FILE NAME: 1.010.050.1 - Engine Wiring 2.4 JTD 20V - Rev8	NOTE: BOOST PRESSURE SENSOR 3 PIN
	PROJECT: HPEZ25/HPE250 - 2.4 JTD 20V	SCALE: not
DESIGNED: G. CUOMO	CHD CODE: 1.010.050.1	SHEET: 1/3
CHECKED: G. CUOMO	SPECIFICATIONS: Unless otherwise specified the dimensions are in mm Tolerances: +10mm-0mm	SIZE: A1
DRAWN: S. LA MANNA	<b>WIRING LAYOUT</b> PROPRIETARY NOTICE:

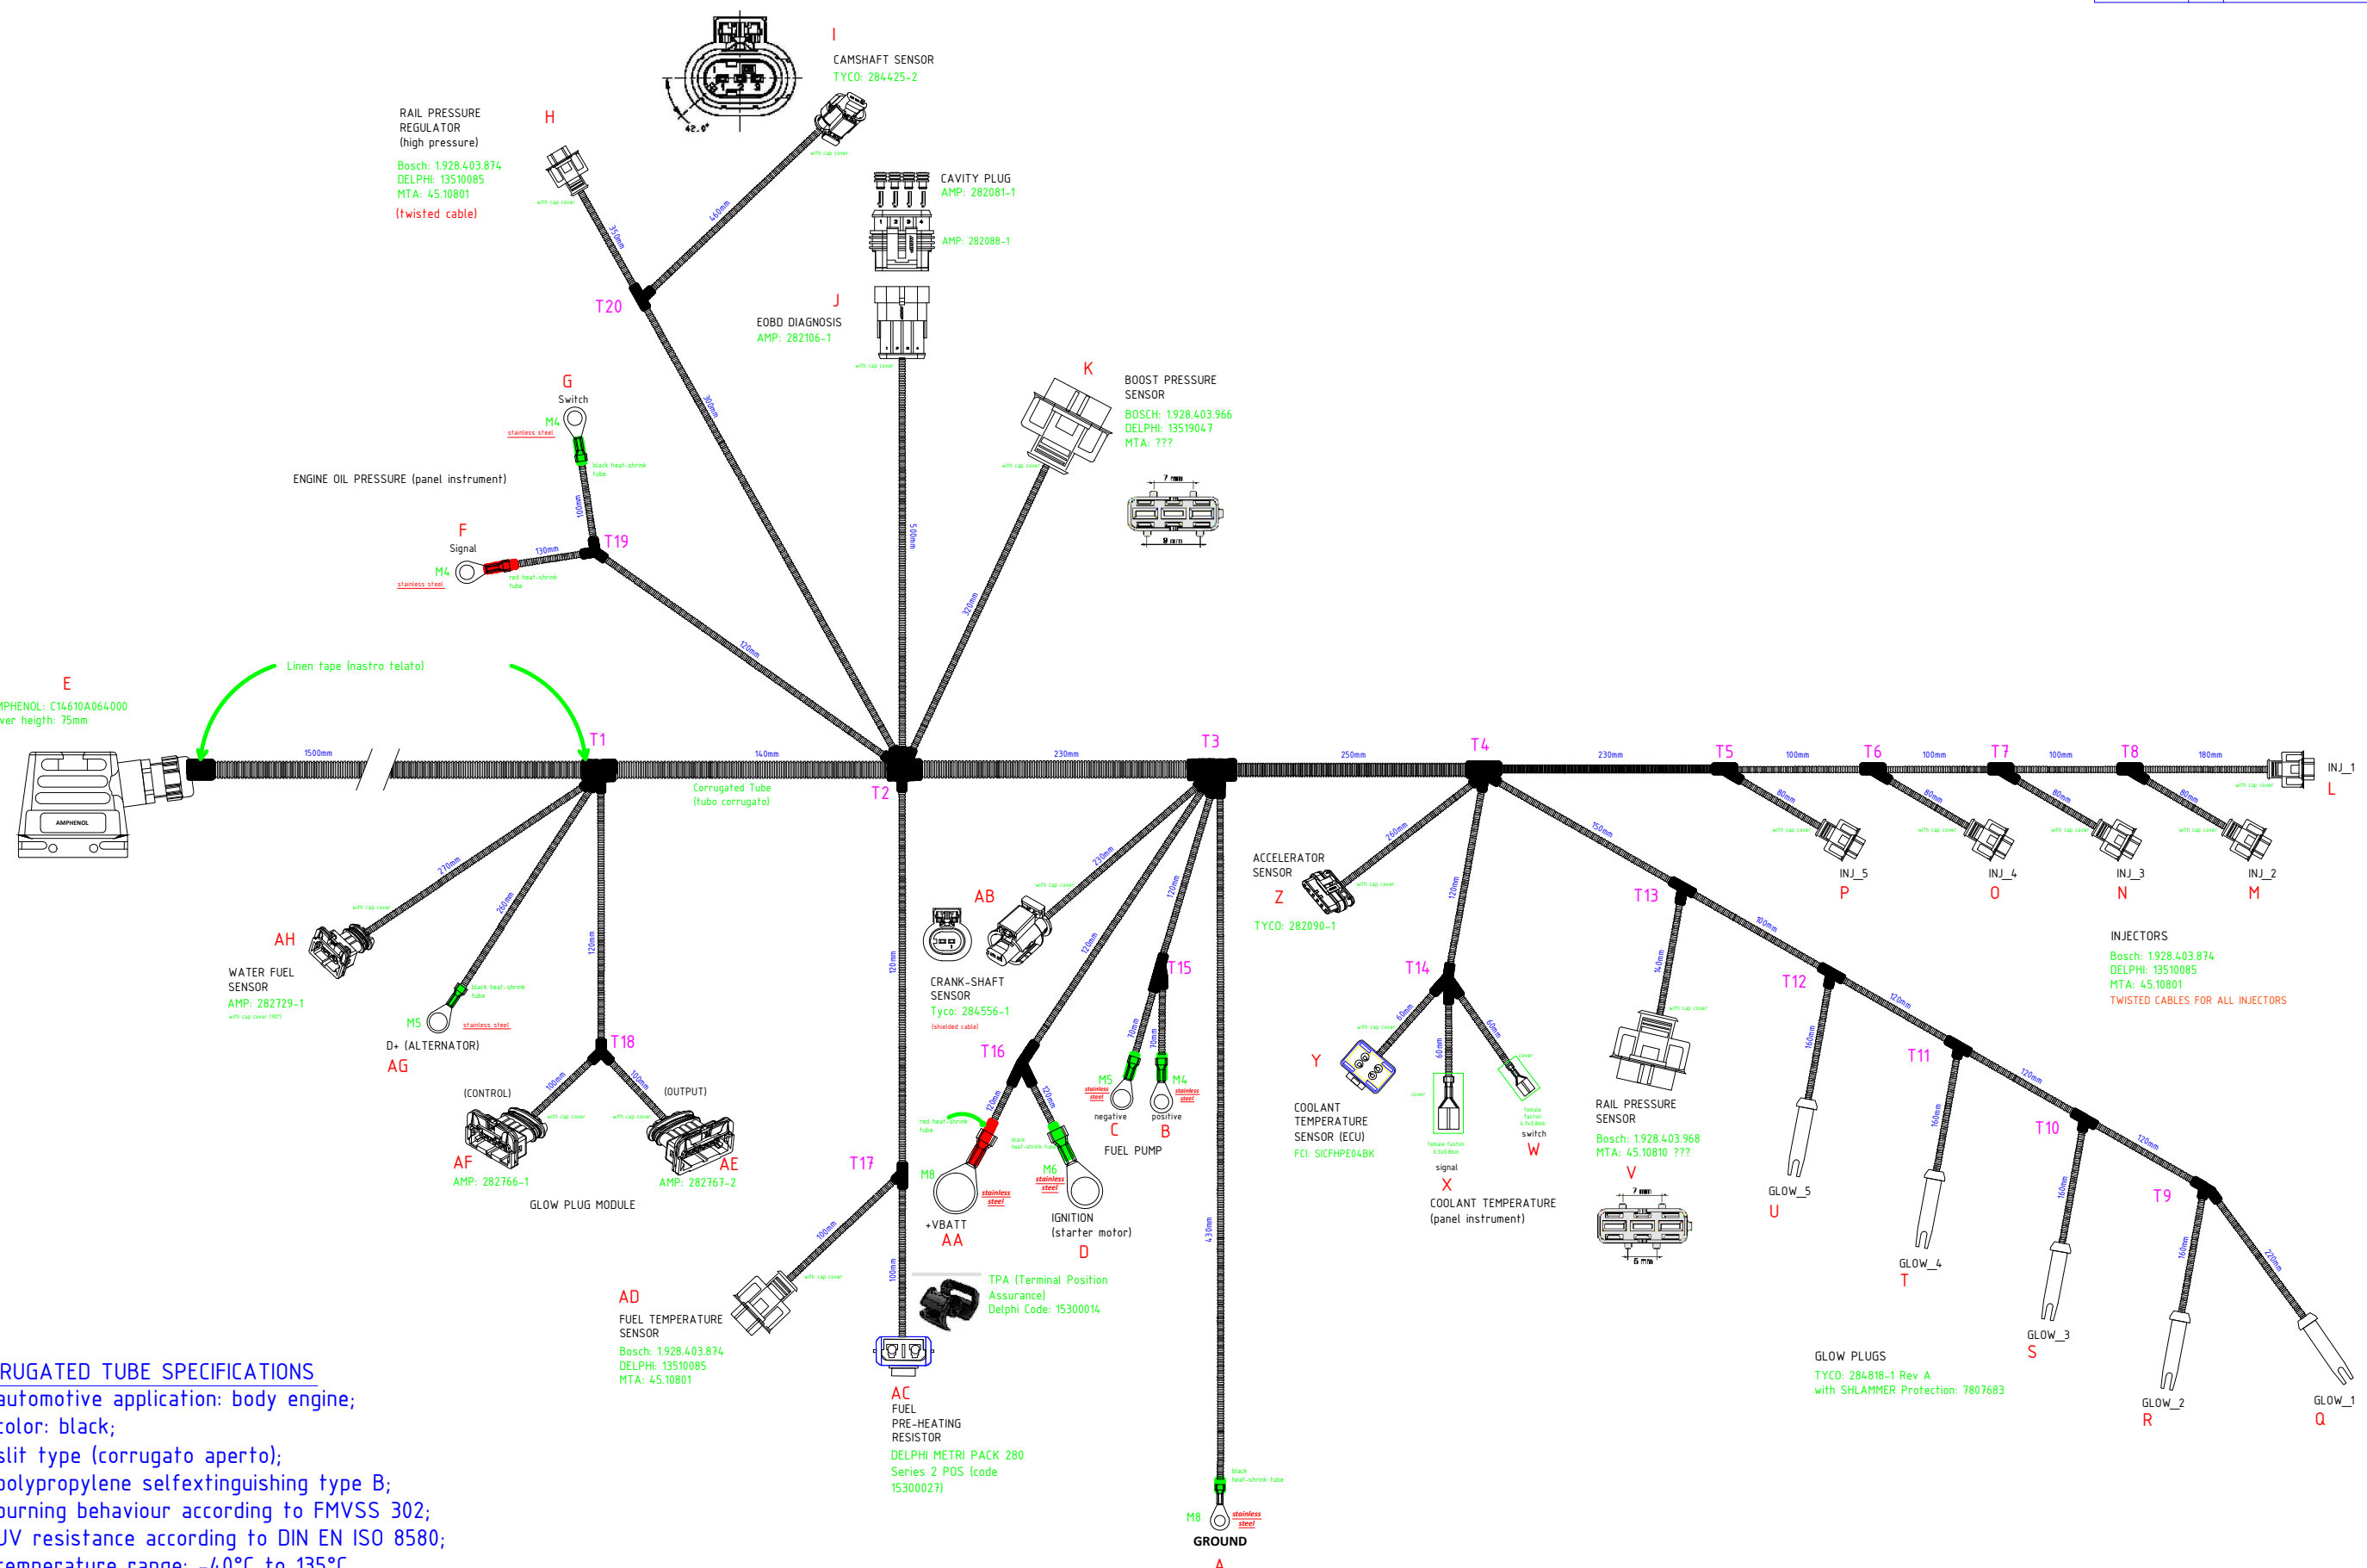
MODIFICHE (REVISIONS)			
ZONE	REV	DESCRIPTION	DATE
	7	From year 2010 to July 2016	10/03/2011
sheet 1 of 3 C4-CS-05	8	Changed lengths: T2-T20 from 550mm to 300mm, T20-H from 100mm to 350mm, T20-I from 210mm to 460mm.	12/07/2016
